Process Sheet

Customer : CU-DAR001 Dart Helicopters Services	Drawing Name : STUB COVER
Job Number : 36863	
Estimate Number : 12415	
P.O. Number :	Part Number : D34941
This Issue : 1/17/2008 S.O. No. :	Drawing Number : D3494 REV B
Prsht Rev. : NC	Project Number : N/A
First Issue : / / Type : LARGE FAB ASSY	Drawing Revision : B
Previous Run : 28946	Material :
Written By :	Due Date : 1/30/2008 Qty: 12 Um: Each
Checked & Approved By : <u>08 01 18</u>	
Comment : Est Rev: A New Issue 06-05-18 JLM	
est rev B ecn 888 06.12.13 EC

DESIGN <i>B</i>	DRAWN BY <i>B</i>	DART AEROSPACE LTD HAWKESBURY, ONTARIO, CANADA	
CHECKED <i>PH</i>	APPROVED <i>PH</i>	DRAWING NO. D3494	REV. B SHEET 1 OF 2
DATE 06.11.28		TITLE STUB COVER	SCALE 1:2
REV	DATE	DESCRIPTION	
A	06.01.16	NEW ISSUE	
B	06.11.28	REVISED FLAT PATTERN, BENDING DIMENSIONS, Ø0.208 X 0.268 SLOTS WERE Ø0.208 HOLES

Part No: D3494 PAR #: 08-003 Fault Category: Eng Design NCR: ~~Yes~~ No DQA: D Date: 08/02/08
 QA: N/C Closed: _____ Date: _____

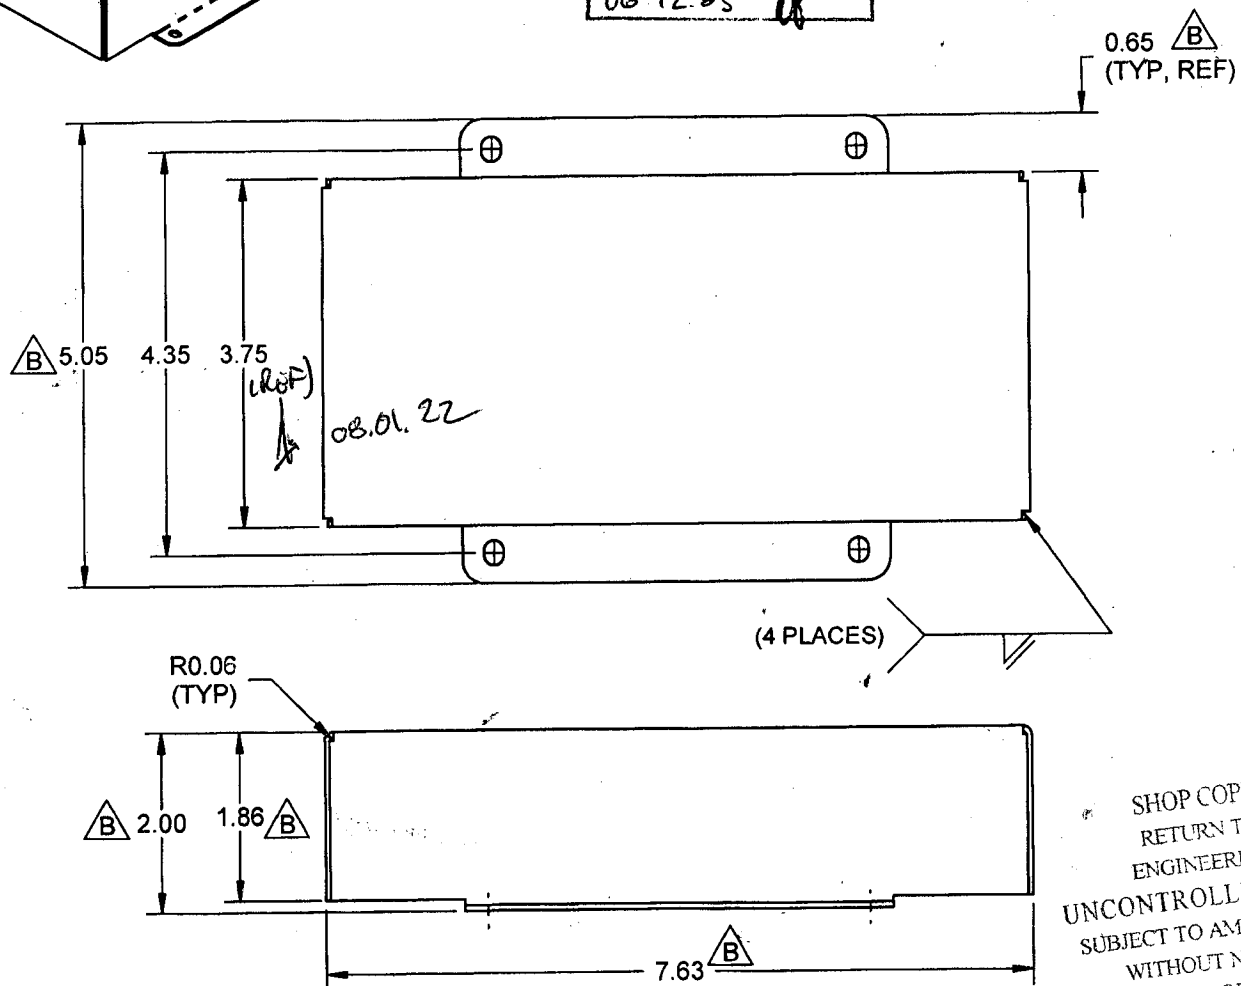
NCR: <u>36863</u>		WORK ORDER NON-CONFORMANCE (NCR)						
DATE	STEP	Description of NC Section A	Corrective Action Section B			Verification Section C	Approval Chief Eng	Approval QC Inspector
			Initial Chief Eng	Action Description Chief Eng	Sign & Date			
08.01.22	7.0	O.G.T SHOULD HAVE BEEN CORRECTED TO 0.725. ADDED (REF) TO 3.75 DIA TO KEEP CENTER TO CENTER OF HOLES (4.35). THIS INCREASE GAP BETWEEN CORNER. LARGE WELD BANDS REQUIRED. R.C. Dwg not updated with the current dimensions	<u>08.01.22</u>	Parts acceptable per Eng. See PAR 08-003 for dwg change.	N/A <u>1/</u>	<u>08-01-22</u>	<u>08.01.22</u>	<u>08.01.22</u>
